RFP 2021-14
REQUEST FOR PROPOSALS
FOR CONTRACT NO. 4-FACILITY IMPROVEMENTS,
PLUMBING
TO THE MATERIALS RECOVERY FACILITY
IN
HILLBURN, NEW YORK
DATED JULY 30, 2021

TO: RECIPIENTS OF THE REQUEST FOR PROPOSALS
FROM: ROCKLAND COUNTY SOLID WASTE MANAGEMENT AUTHORITY d/b/a
ROCKLAND GREEN
DATE: SEPTEMBER 1, 2021
SUBJECT: ADDENDUM NUMBER 4

This Addendum Number 4 provides modifications to the following appendices: Appendix B, Specifications, Appendix C, Contract Drawings, Appendix D-1, Division of Responsibility, and Appendix O, Statement of Work; as well as a modified Price Proposal Form.

Appendix C, Contract Drawings to the RFP has been modified as explained below. The modified Contract Drawings are redlined to reflect the changes and attached hereto as Attachment 3.

2 PARTIAL FIRST FLOOR PLAN - WATER AND GAS PIPING
 P-101-BP SCALE: 3/16"=1'-0"

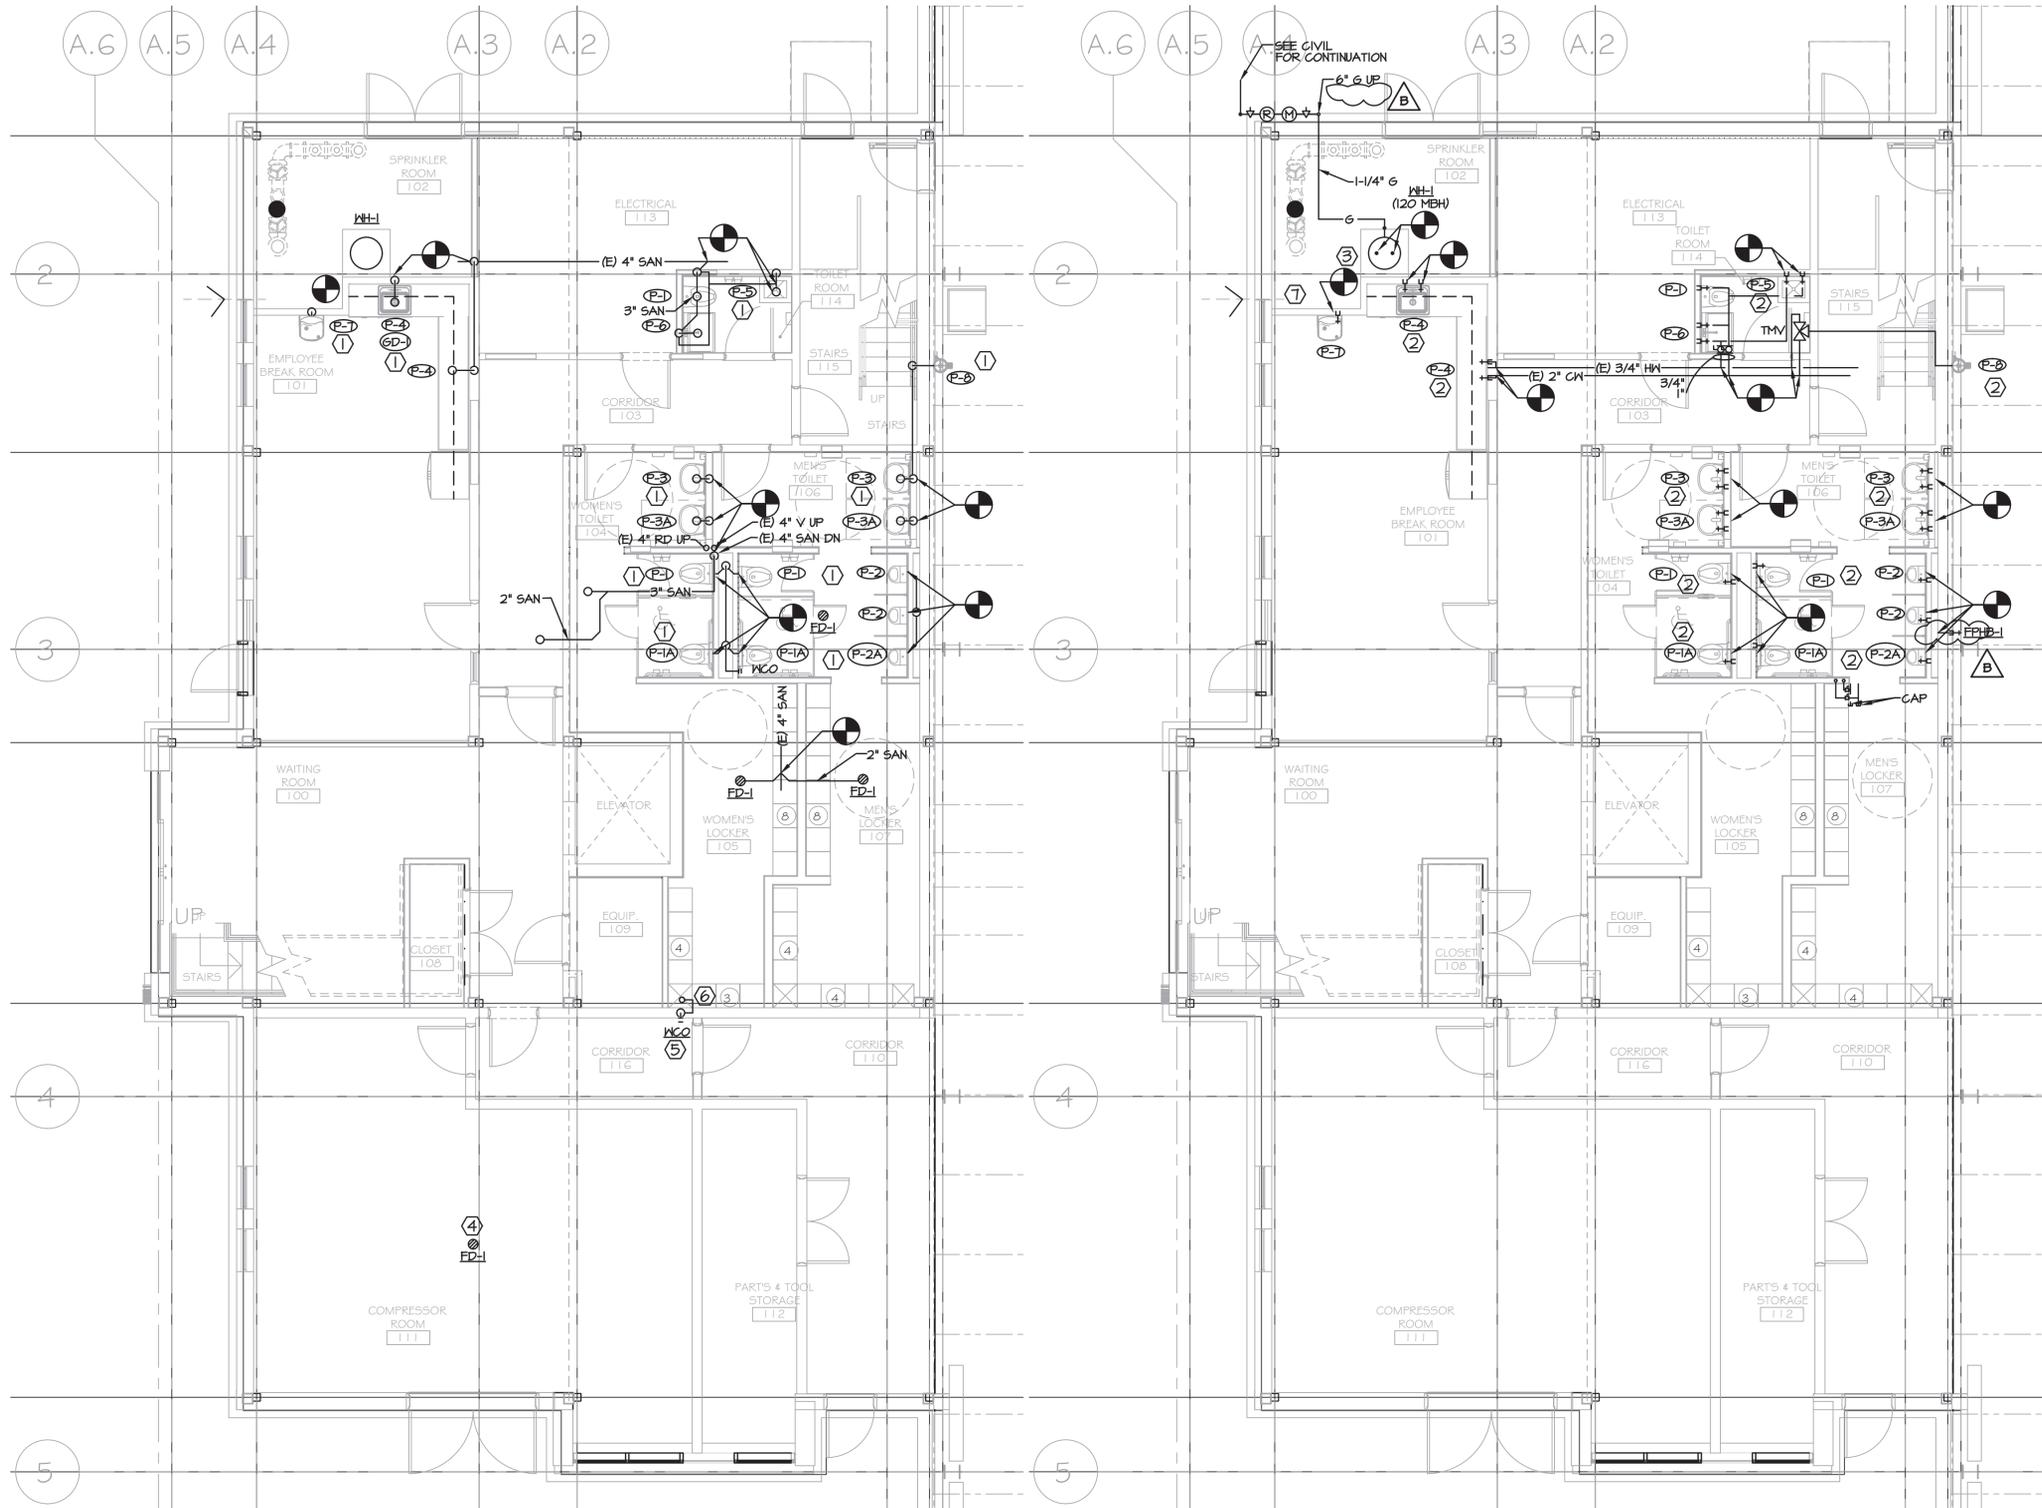
1. Drawing P-001
 - A. Added FPHB-1 in Plumbing Schedule.
2. Drawing P-101
 - B. Revised Gas Load, Added 2 more UH-1's.
 - C. Added FPHB-1.
3. Drawing P-103
 - A. Added KEY NOTES.
 - B. Revised Gas Piping for 2 new UH-1's.
 - C. Added Pump P- 1 and Holding Tank.
 - D. Added FPHB-1.
 - E. Added Room Tags.
4. Drawing P-104
 - A. Added Trench Drain and Sand/oil Interceptor.
 - B. Revised Storm Gutter System.
 - C. Added UH-1's and Gas Piping.
 - D. Added KEY NOTES.
5. Drawing P-301
 - A. Revised Gas Piping to (MRF) 420 Torne Valley Rd.
 - B. Added UH-1's.

GAS APPLIANCE	GAS INPUT (MBH)
UH-1	120
UH-1 (x2)	400 EACH
UH-1-4 (x4)	80 EACH
UH-5-6 (x2)	150 EACH
RTU-1	250
RTU-2	50
RTU-3	50
TOTAL:	1420 MBH OR CFH

LONGEST GAS APPLIANCE FROM METER:
 UH-1 @ 450 FT FROM METER.
 SCHEDULE 40 LESS THAN 2.0 PSIG - 0.3" WC PRESSURE DROP, SG = 0.60.
